Access Compliance Report

Public Rights-of-Way

Intersection ID: 26451	Main Street: PARK_RD	Cross Street: KINGFISHER_DR	Location: NW
ADA ID: 27EF154FDDAA	Ramp Type: PerpDiag	Initial Pass/Fail: Fail	Overall Compliance: No
			Severity Score: 21.25

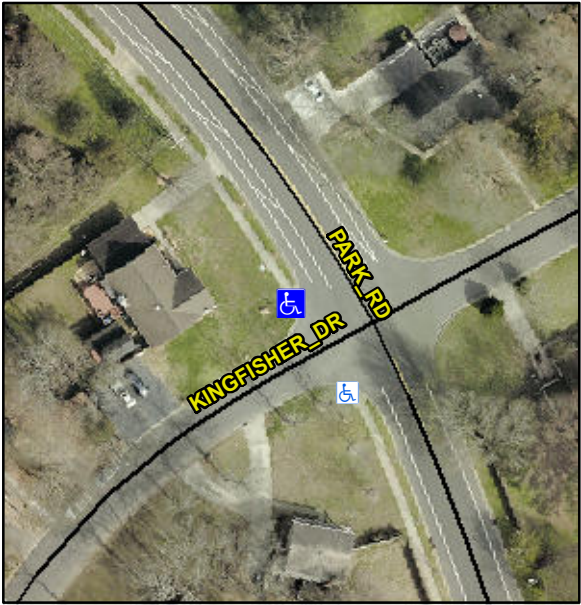
Codes/Mitigation Info/Possible Solution			Field Measurements/Component Compliance		
	Possible Solutions:		Compliance	Description	Data
	Remove & Replace Curb Ramp With Two New Directional Ramps or Equivalent.		No	Ramp Length (in)	70.0
			No	Ramp Width (in)	46.5
			N/A	Flare Type LT	N/A
			N/A	Flare Slope LT (%)	N/A
			N/A	Flare Traversable LT?	N/A
			N/A	Landing Length (in)	N/A
			N/A	Landing Width (in)	N/A
			N/A	Landing Slope (%)	N/A
			N/A	Landing X Slope (%)	N/A
<p>Surveyor Notes:</p> <p>N/A</p> <p>PROW/ADA:</p> <p>Not Found, R304.5.1, R304.2.2</p>			N/A	Flare Type RT	N/A
			N/A	Flare Slope RT (%)	N/A
			N/A	Flare Traversable RT?	N/A
			N/A	DWS Provided?	N/A
			N/A	DWS Contrast?	N/A
			N/A	DWS Length (in)	N/A
			N/A	DWS Full Width?	N/A
			N/A	DWS Offset (in)	N/A
			N/A	Shared Landing?	N/A
			N/A	Gutter Ponding?	N/A
			N/A	Gutter Lip Ht (in)	N/A
			N/A	Painted X Walk1?	No
				X Walk 1 Direction	To S
			N/A	X Walk 1 Width (in)	N/A

X Walk 1 Slope (%)	1.1
				X Walk 1 X Slope (%)	0.1
			N/A	Ramp inside XWalk1?	N/A
				Road Slope (%)	1.0
				Road X Slope (%)	2.3
			N/A	Any Obstructions?	N/A
				Obstruction Type	
Total Cost:		\$ 3200.00			
			N/A		N/A
			Yes	Surface Condition? (G/P)	Good
